Our ref: PR134198

Date: 14 April 2022

Change to Approval – Material Change of Use and Reconfiguring a Lot – Carseldine Village Masterplan – 520 Beams Road, Carseldine (Lot 322 on SP172124) (EDQ Reference: DEV2018/932/3)

Figure 1: Approved Masterplan

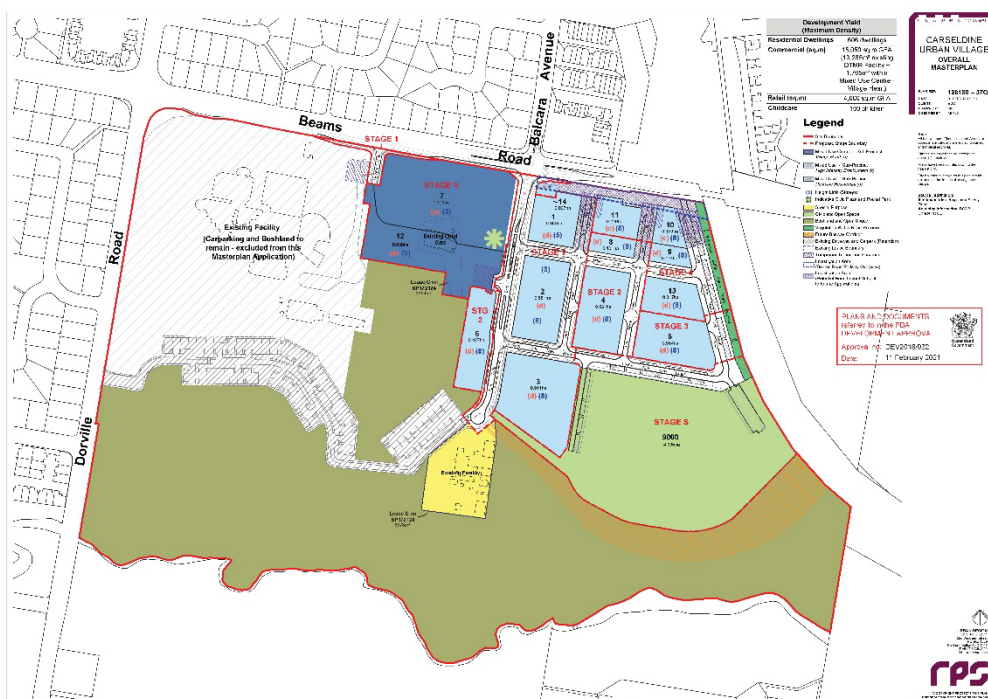
The proposed changes involve the removal of the Mixed Use – sub precinct High Intensity Employment (c) and replacement with Mixed Use – Parkside residential (d). These changes will be offset through the provision of an additional height allowance within the Mixed-Use Centre – sub precinct Village Heart (a), specifically:

- 5 storeys to 8 storeys for lots V002 and V003; and
- 3 storeys to 5 storeys for lot V001.

The proposed changes involve the removal of the Mixed-Use Sub-precinct High Intensity Employment (c) and replacement with the Mixed-Use Sub-precinct Parkside residential (d).

- Increased height from **5 storeys to 8 storeys** on V002 and V003.
- Increased height from **3 storeys to 5 storeys** at V001.
